March 5, 2015
BOARD OF COUNTY COMMISSIONERS
ORANGE COUNTY, FLORIDA

ADDENDUM NO. 6
IFB NO. Y15-742 PH
SOUTH WATER RECLAMATION FACILITY
PRELIMINARY TREATMENT STRUCTURE ODOR CONTROL SYSTEM

PROJECT NO.:	110013
SCALE:	NOTED
DRAWING NO.:	E02
REVISION:	0
SHEET NO.:	16 OF 19

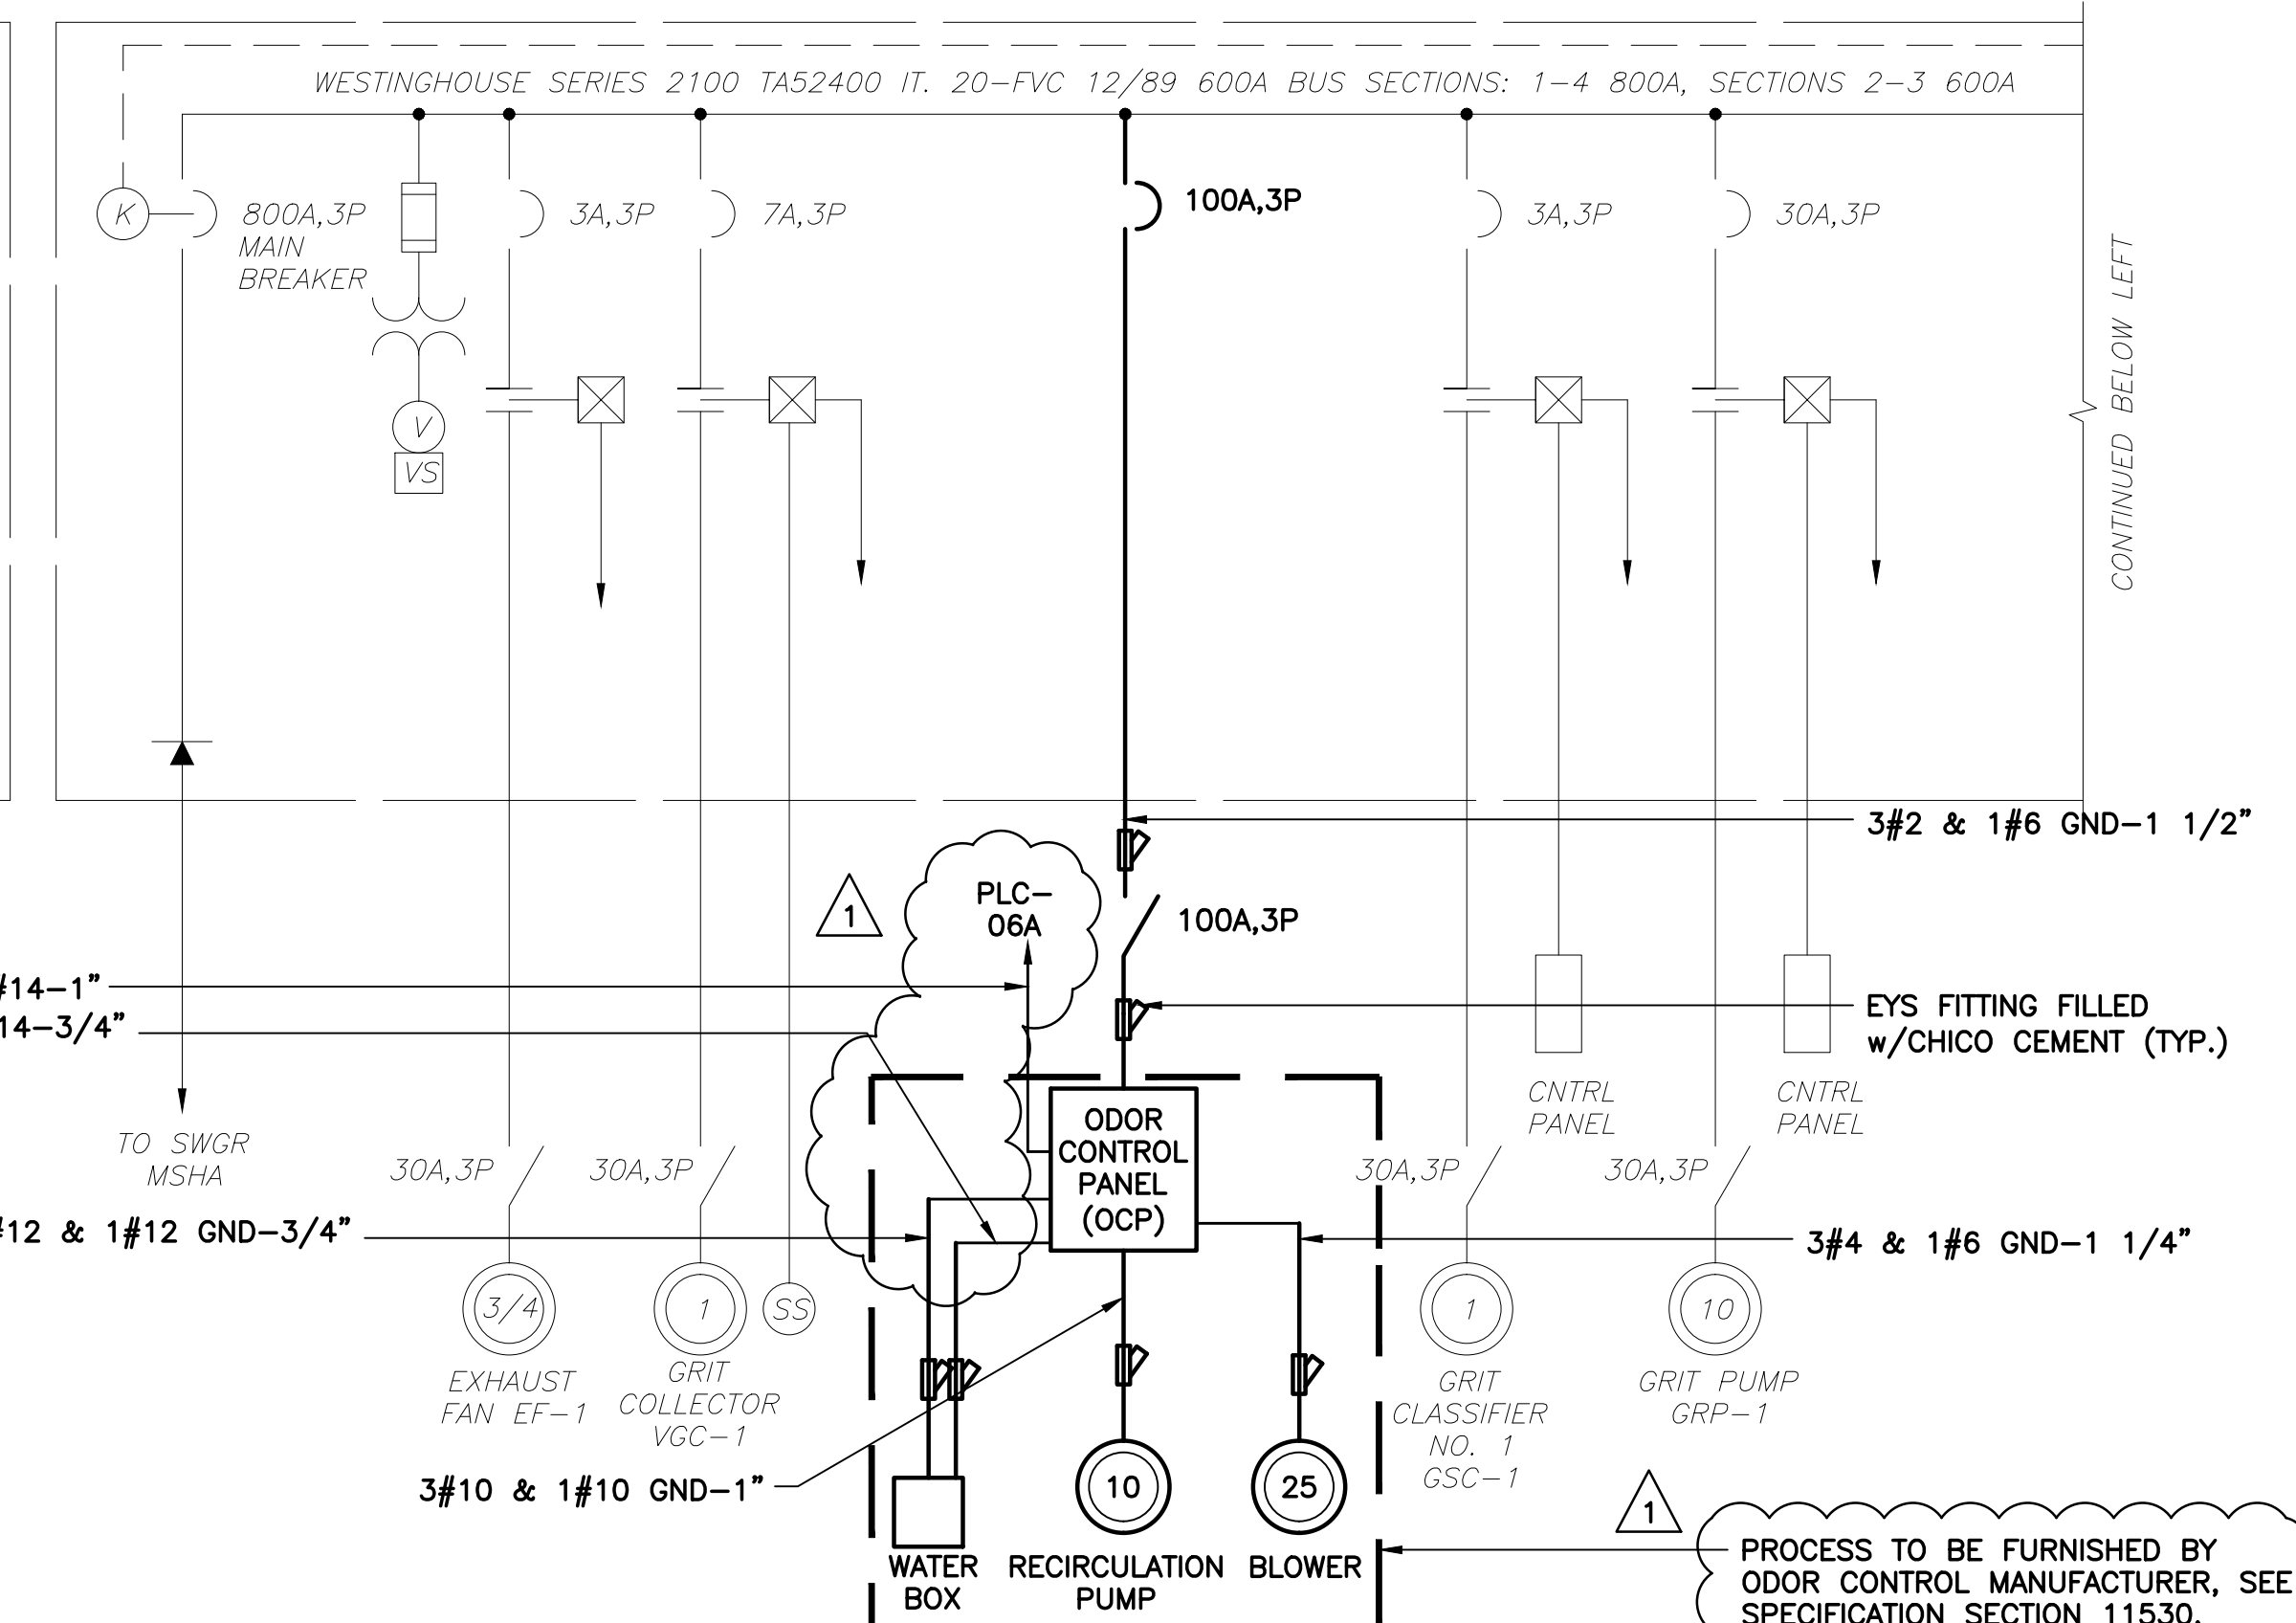
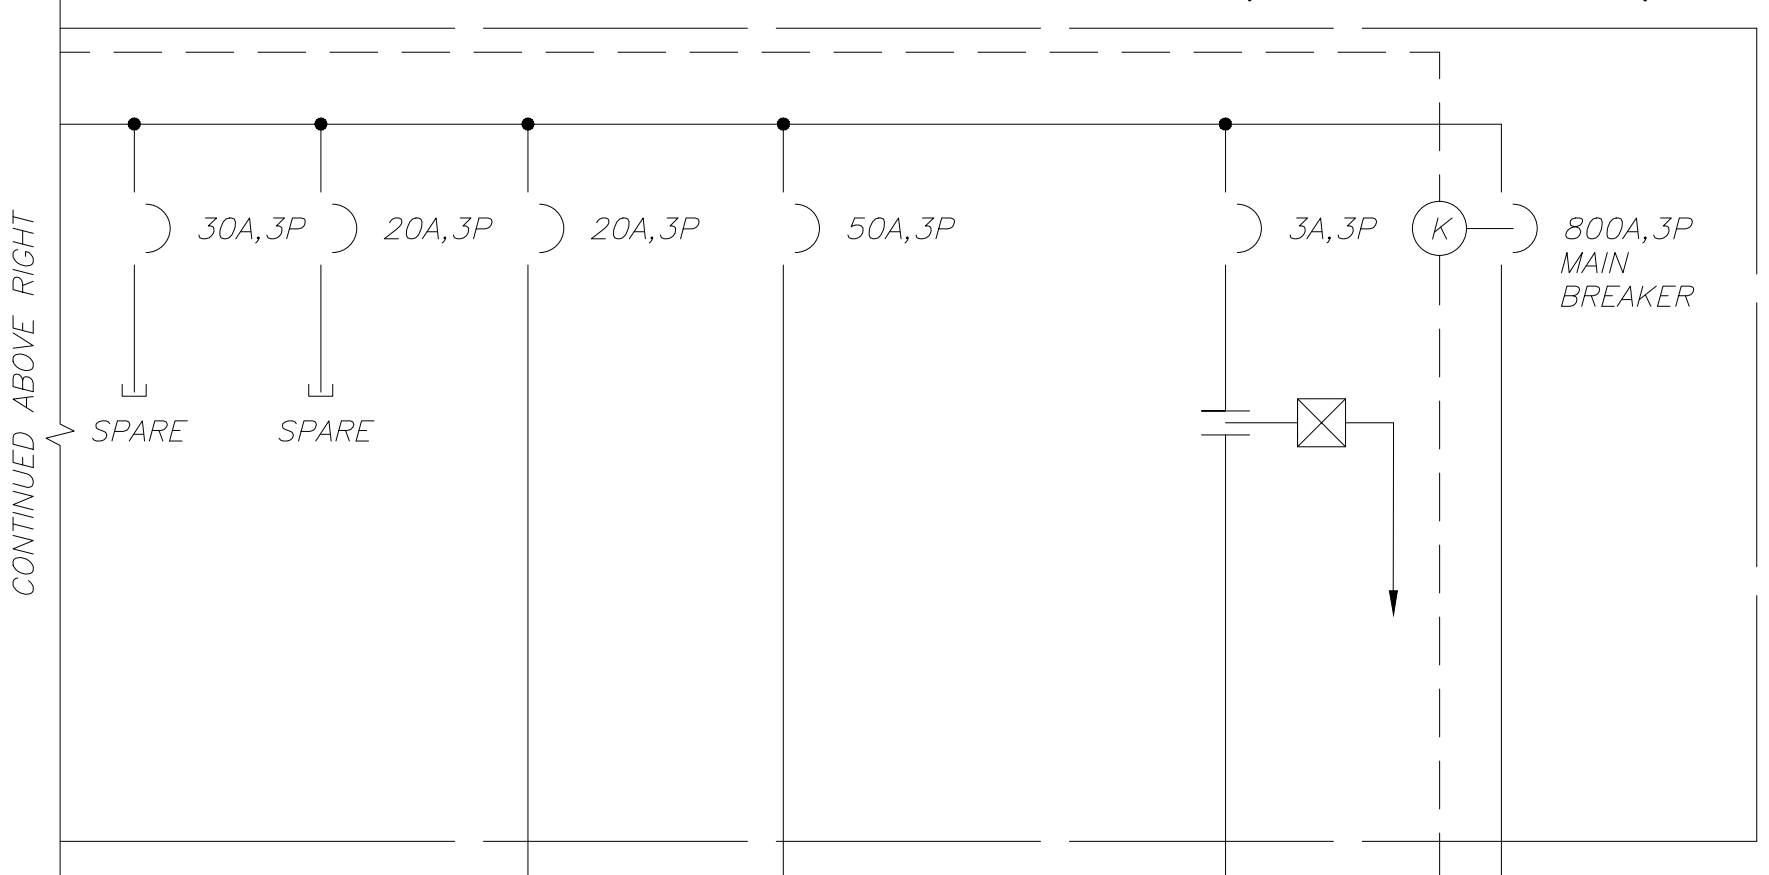
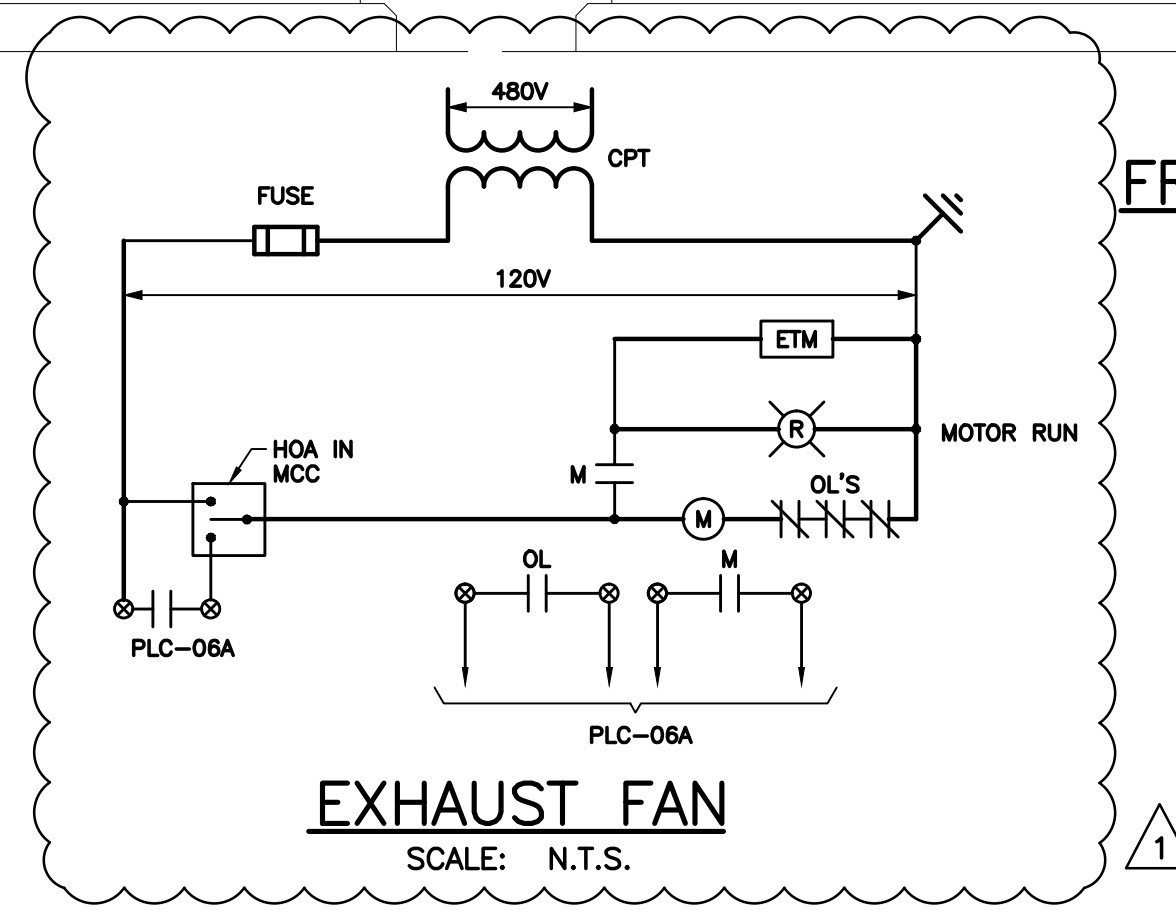
1. Drawings E02 shows that we are running 10#14 wires from the Odor Control Panel to PLC-04A. Drawings E04 shows the location for PLC-06A. Please specify the location of PLC-04A.?

1. Exhaust fan is shown on sheet E-02 as 1.5hp and is shown on sheet E-04 as 10hp. Please clarify the correct size.

2. On electrical drawing E02 it shows conduit sizes for Water box, Recir. pump and Blower, but it also states that the electrical contractor is ONLY responsible for the line side of the control panel and extend conductor to PLC. Please clarify that this is correct and that there will not be any conduit or conductors required by the electrical sub on the Skid. Only to PLC and MCC USKA.

Drawings E02 revise callout indicating ~~PLC-04A~~ PLC-06A.

The exhaust fan to be rated at 1.5HP per Drawing E02 and specification section 15800, 2.01, E. Refer to attached revised Drawing E04.

The Electrical Contractor shall furnish and install all conduit, wire and EYS fittings for the Odor Control System as called-out on Drawing E02. Odor Control System equipment is furnished by odor control manufacturer under specification section 11530. Refer to attached revised Drawing E02.

PROJECT NO.: 110013	
SCALE: NOTED	REVISION: 0
DRAWING NO. E04	SHEET NO.: 18 OF 19

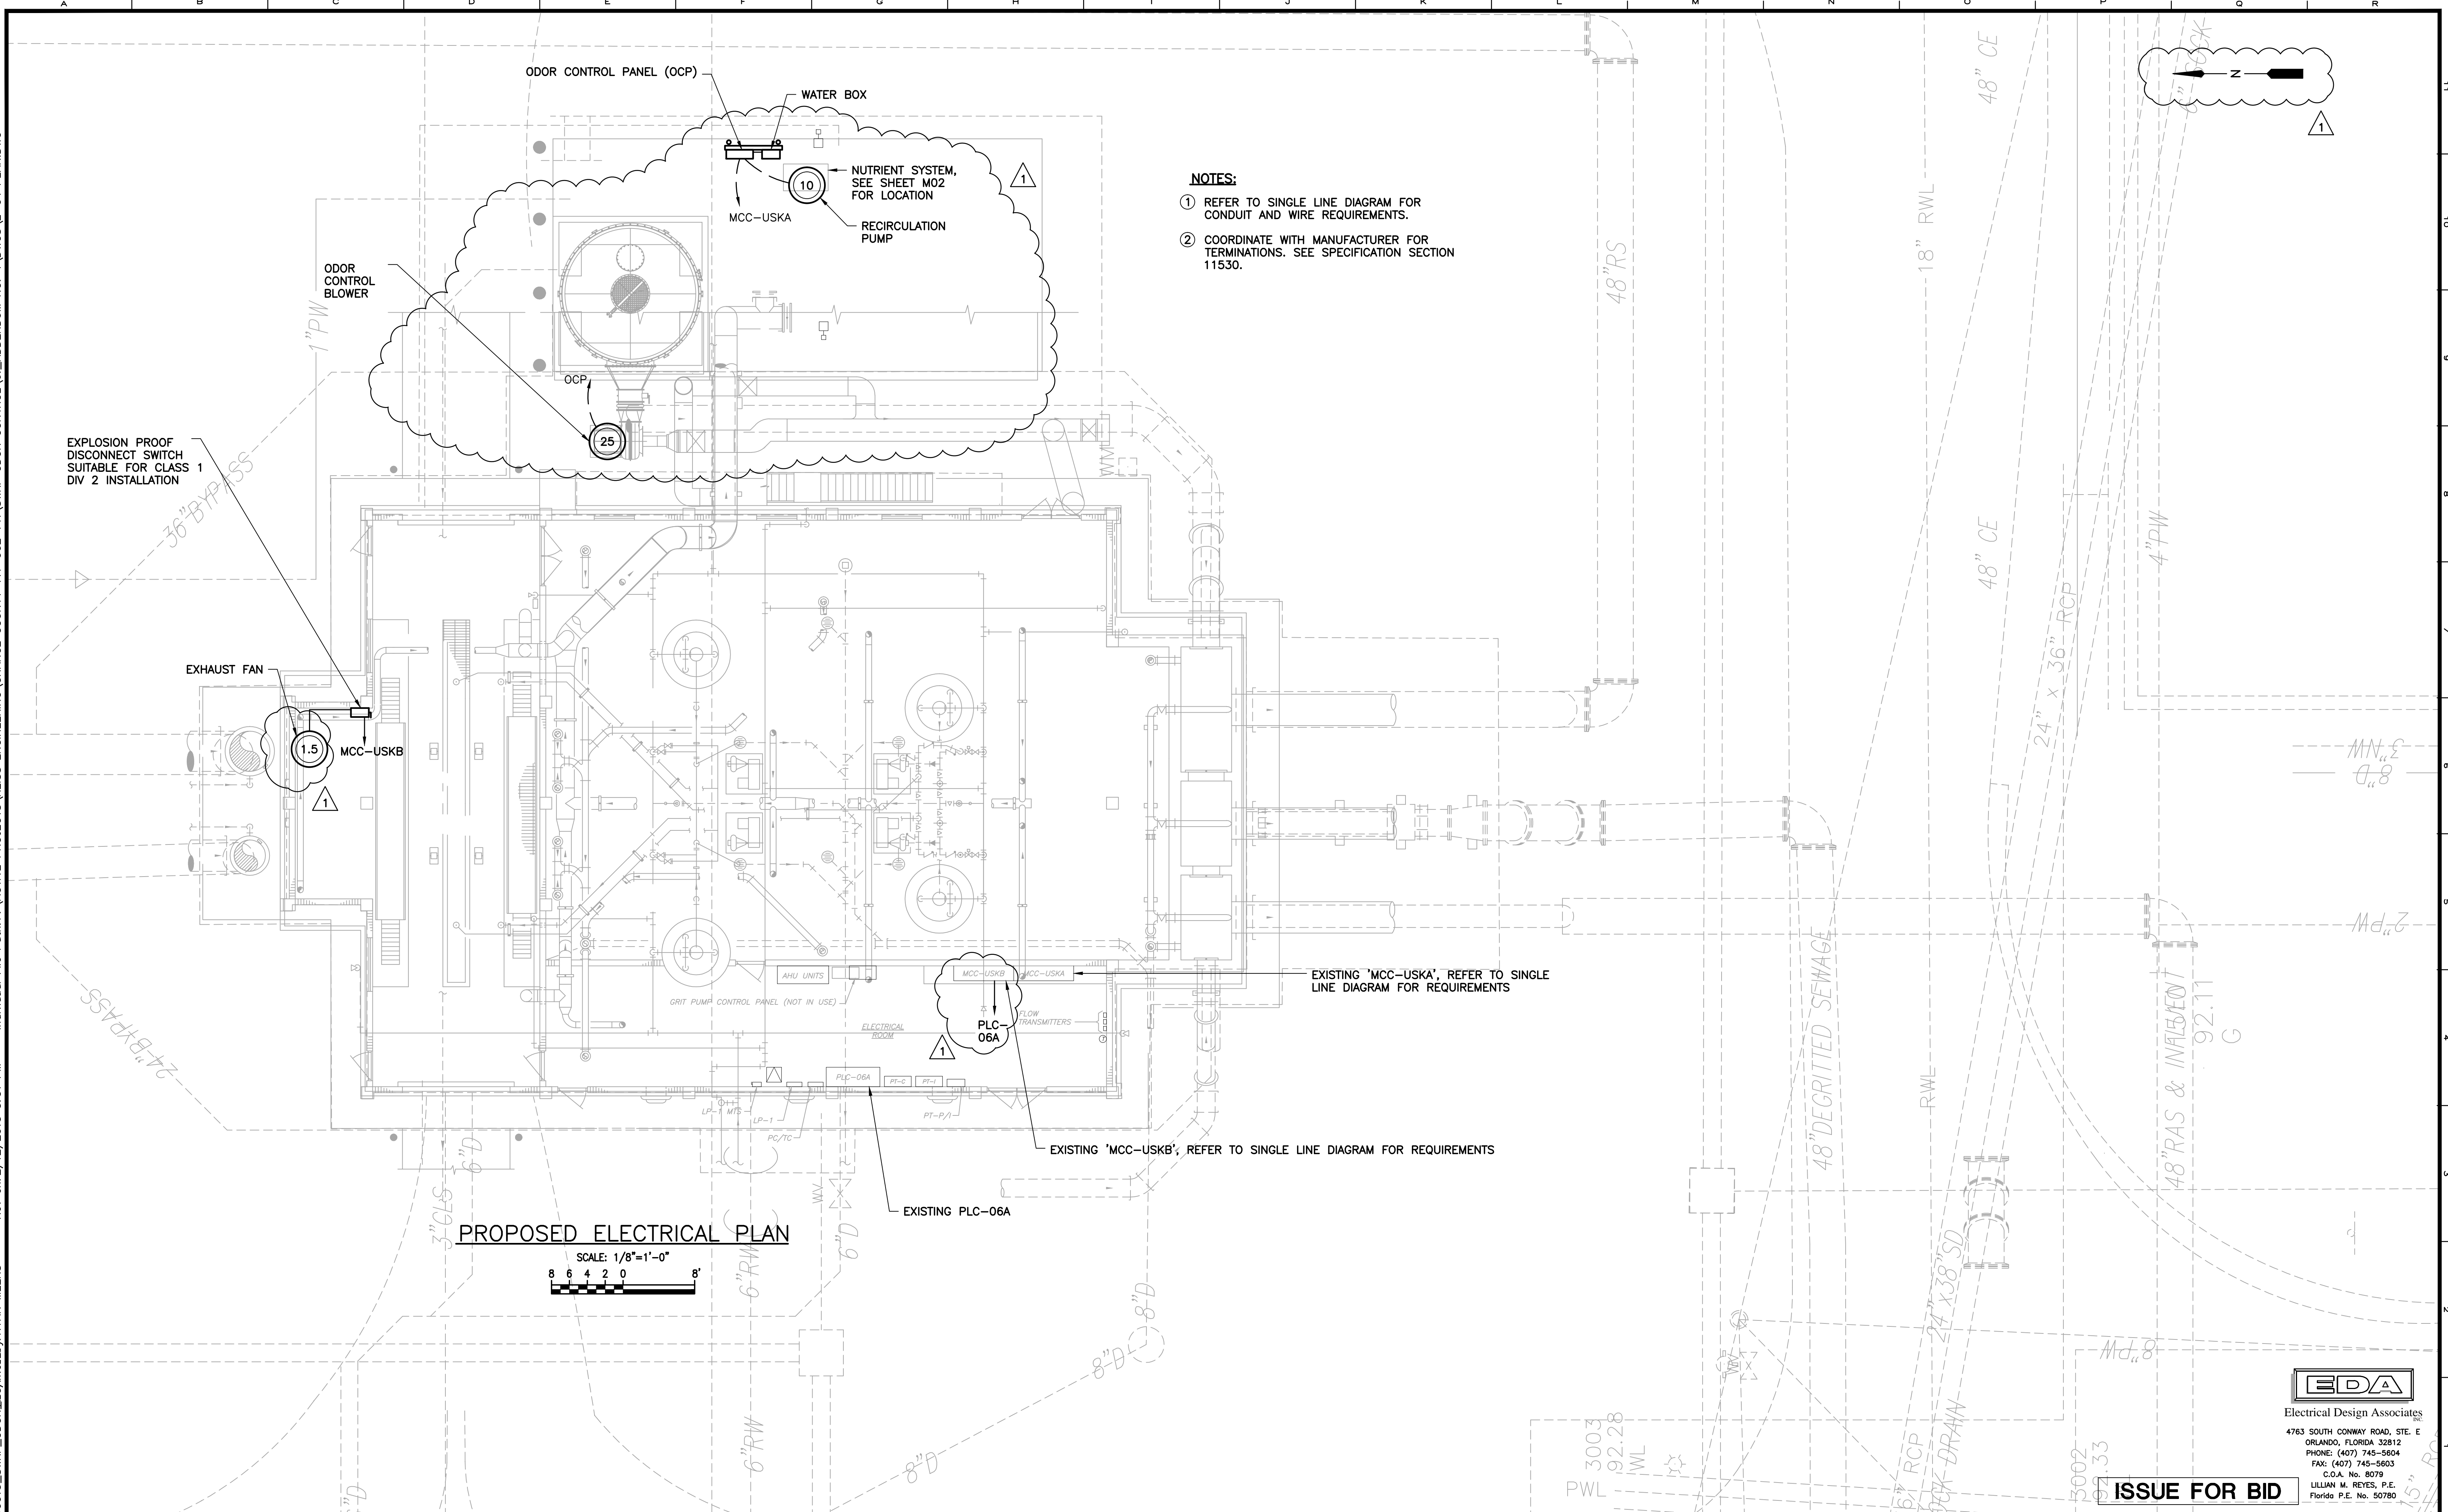
3. The Recirculation pump is not depicted on the electrical drawings, only on the riser.

Refer to attached revised Drawing E04.
